In the United States Patent and Trademark Office

For: Self-Route Expandable Multi-Memory Packet Switch with Distributed Scheduling Means

Serial Number: 09/683,429

Response and Amendment Under 37 C.F.R. §1.111

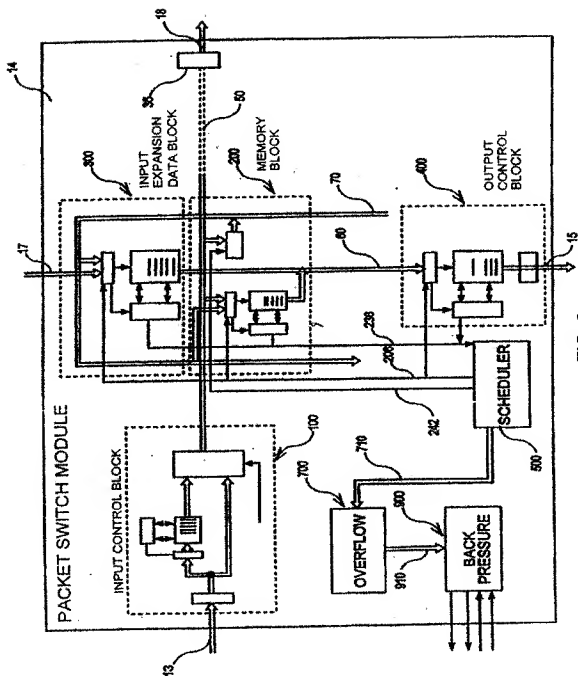
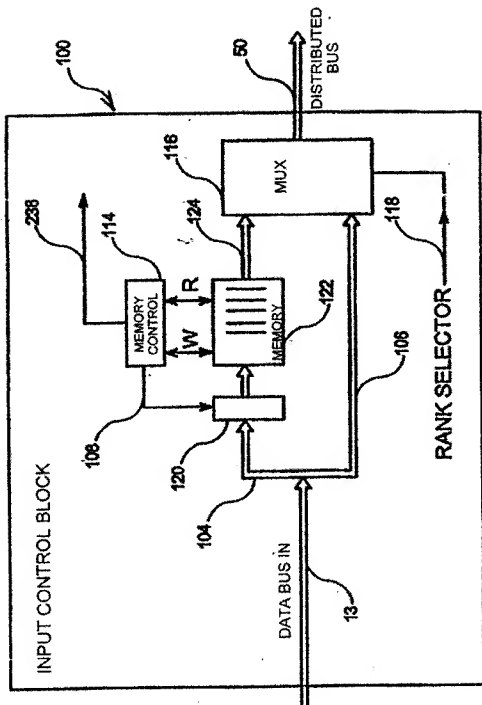
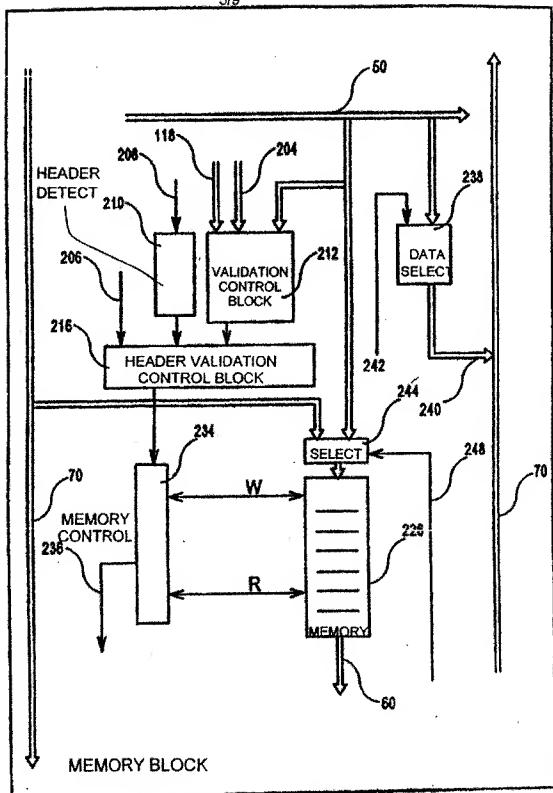
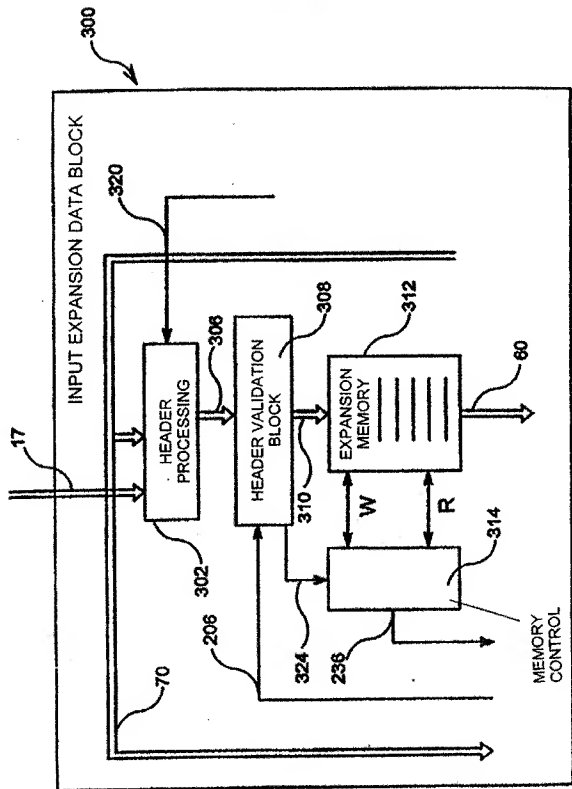
The Office Action stated an objection to Figures 3-8 as failing to comply with 37 CFR 1.121(d) because descriptive labels necessary for understanding the drawings are missing. The Office Action also stated that the quality of the connections shown on Figure 8 is not acceptable. A proposed set of drawings to overcome the objections is attached to this amendment as Appendix A. Each sheet has been labeled "Replacement Sheet" to be in compliance with 37 CFR 1.121(d).

Therefore, Applicants respectfully submit that the objection to the drawings has been overcome.
